# Product Advisory

<b>Product Family:</b>	Productivity2000	<b>Number:</b>	PA-P2K-013
<b>Part Numbers:</b>	P2-08TRS rev B3	<b>Date Issued:</b>	12/16/2021
<b>Subject:</b>	POTENTIAL SAFETY CONCERNS Urgent-Mandatory Hardware Replacement	<b>Revision:</b>	Rev C

## Follow-up to Product Advisory PA-P2K-013, Rev. B dated 09/22/2021

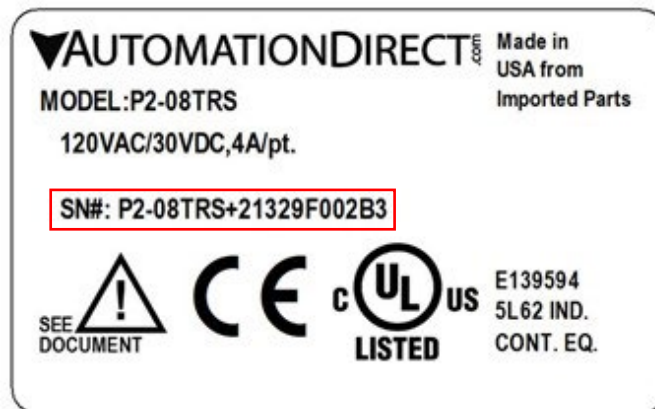
A hardware replacement is required for every P2-08TRS rev B3 module purchased between May 17, 2021 and August 26, 2021. P2-08TRS rev B3 modules are identified by serial numbers on the Productivity2000 module product label as shown below. The module revision can also be found in Productivity Suite, Hardware Configuration, CPU, click on the P2-08TRS module, Module Info.

- P2-08TRS+xxxxxFxxxB3 – Note, the last two characters denote the product revision. Only if the last two characters are “B3”, then this module must be replaced.

It is necessary to replace all P2-08TRS rev B3 modules. Please immediately visit <https://www.automationdirect.com/myaccount/returns> to submit a Product Returns form which creates the RMA, automatically generates your replacement order, and provides you with a shipping label to return the defect product. Please be sure you are logged in to the account from which the module was purchased. Replacement orders may take 2-10 business days to process before shipment. It is essential the affected hardware be returned to AutomationDirect.com within 10 days after the receipt of the replacement module.
